SERVICE-INFO

Different versions of the overrunning alternator pulley 535 0199 10

Manufacturer:	Toyota
Models:	Echo, Yaris, Yaris Verso
Engine:	1.4 D4d
OE no.:	27415-33020
Part no.:	535 0199 10

Image 1: First version

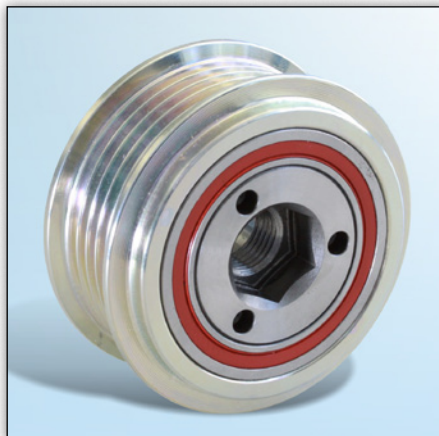
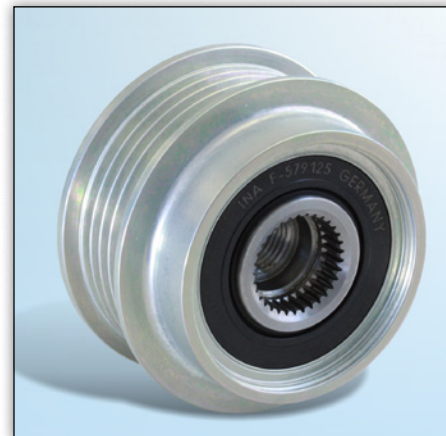
The images show the two different versions of the overrunning alternator pulley 535 0199 10.

The key differences between the two versions are the bearing seals and the fixture for the special tool used for removal, testing and assembly.

Despite the different versions, the overrunning alternator pulleys can be used without restrictions for the vehicles specified in the catalogue.
